AMG models with torque converter 725.0 (NAG3 Classic) and M177/ M279 engine - Harsh shift concerns due to speed sensor installation

Topic number	LI27.00-P-080462
Version	3
Function group	27.00 - General
Date	4/29/26
Validity	Affects all 167 with M177 engine and transmission 725.085 (NAG3 Classic w/ torque converter) produced as of July 1, 2025 Affects all 223 with M279 engine and transmission 725.095 (NAG3 Classic w/ torque converter) produced as of July 1, 2025 Older models with 725.085/095 (NAG3 Classic w/ torque converter) transmissions were NOT affected in production, but may have received affected replacement parts (A725 270 55 09) during valve body replacement
Reason for change	Updated part number

Attachments	
File	Description
Valve body - ECU serial number and date code.jpg	Figure 2

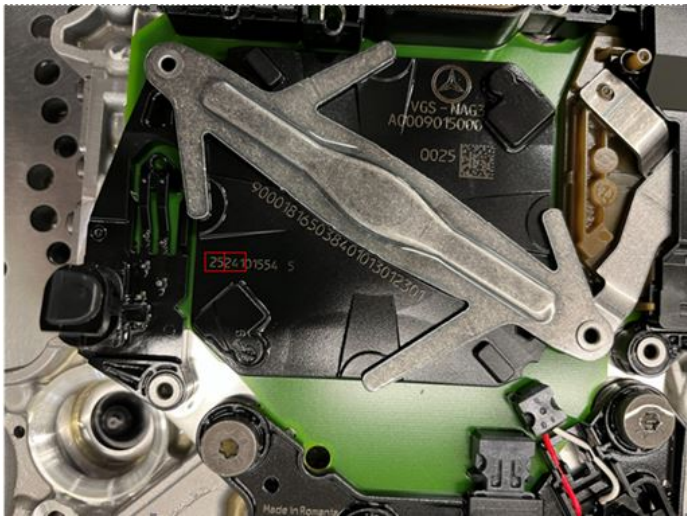
1. Collect initial transmission EEPROM file
 2. Check EEPROM .txt file for VGS control unit serial number and production date (attachment figure 1)
- If the valve body is already removed, you can inspect the control unit for its stamped serial number (attachment figure 2)

- Verify the new valve body production date is outside of day 182-296 of 2025 (attachment figure 2)

If the production date is or is within 25182-25296 (07/4/25-10/23/25):

The complete valve body will require replacement.
